KEWAUNEE NUCLEAR PLANT

Amendment No. 62
License No. DPR-43

AMENDMENT NO. 62 TO FACILITY OPERATING LICENSE NO. DPR-43

SAFETY EVALUATION BY THE OFFICE OF NUCLEAR REACTOR REGULATION
RELATED TO AMENDMENT NO. 62 TO FACILITY OPERATING LICENSE NO. DPR-43

FIGURE TS 3.10-2 HOT CHANNEL FACTOR
NORMALIZED OPERATING ENVELOPE

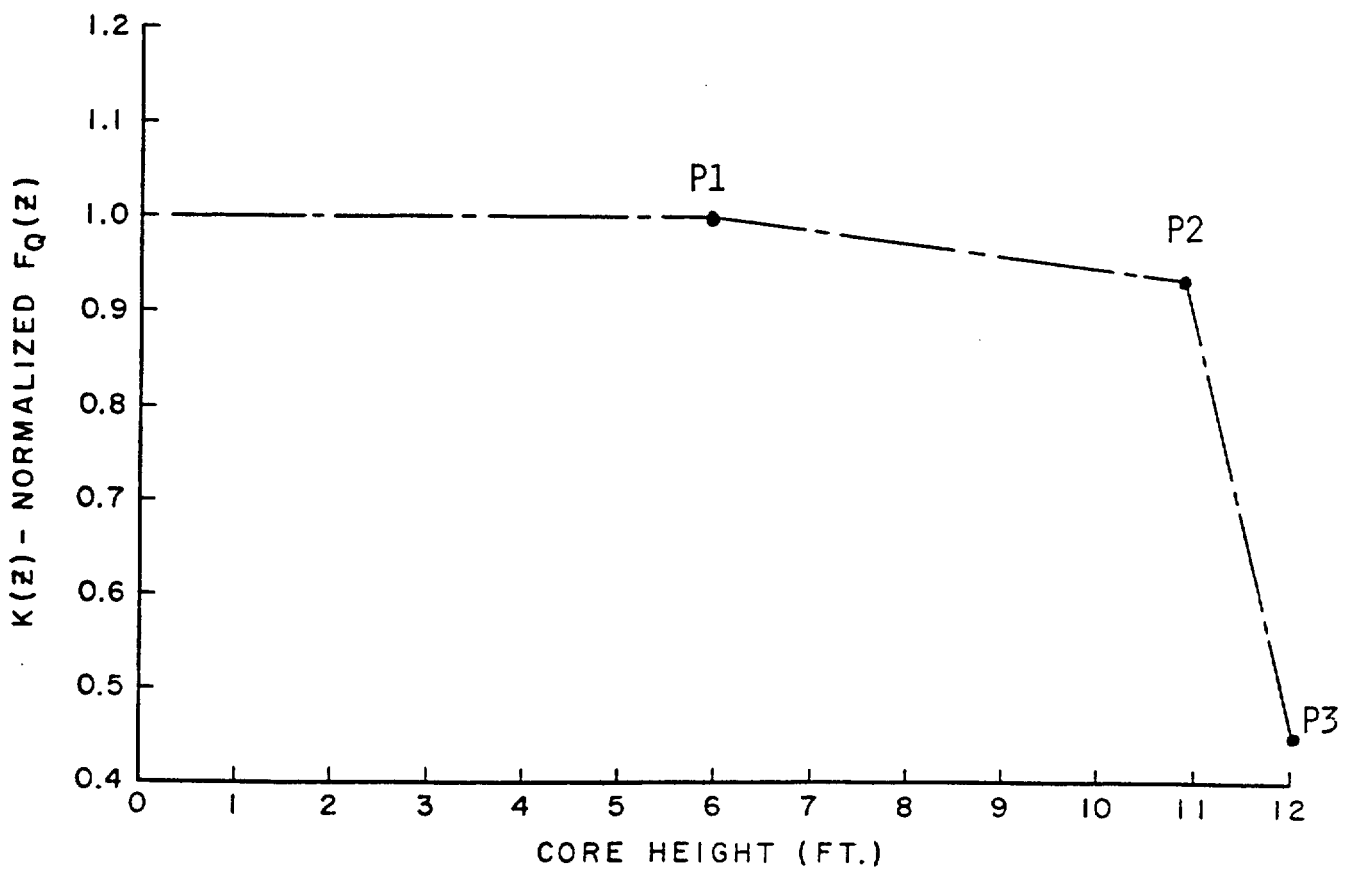
- (3) in Section b.1.A: the removal of the burnup dependent definition for Exxon fuel.
- (4) in Section b.1.B: the removal of the burnup dependence of $F_{\Delta H}$ for Exxon fuel, thus keeping the value of 1.55 for that fuel above 24,000 MWD/MTU.
- (5) in Section b.4: a change in the F_Q factors for equilibrium conditions corresponding to the change in (1) and (2) above, i.e., to 2.14 for Westinghouse fuel and 2.28 for Exxon fuel.
- (6) in Section b.4: a change in the figure number for the definition of $V(z)$.
- (7) in Figure 3.10-2, as referenced in Section b.1.A: new values are provided for the $K(z)$ curve corresponding to the new values of F_Q for Westinghouse and Exxon fuel.
- (8) in Figure 3.10-6 as referenced in Section b.4: a new figure number for what had been Figure 3.10-7 since the old Figure 3.10-6 giving the burnup dependence of Exxon fuel has been removed.

limit of 49,000 MWD/MTU for the Exxon fuel which was an additional basis for that analysis. The new $K(z)$ curves are based on the new F_Q values with a separate curve for Westinghouse and Exxon fuel. The curves were calculated with the standard Westinghouse formulation. This is acceptable for the Westinghouse fuel. The acceptability of this formulation for the Exxon fuel is provided in the Exxon Fuel LOCA Analysis section of this evaluation.

Westinghouse Fuel K(z) Coordinates	Exxon Nuclear Fuel K(z) Coordinates
P1 (6,1.0)	P1 (6, 1.0)
P2 (10.99, 0.932)	P2 (10.84, 0.938)
P3 (12, 0.467)	P3 (12, 0.438)
Normalized to 2.14	Normalized to 2.28
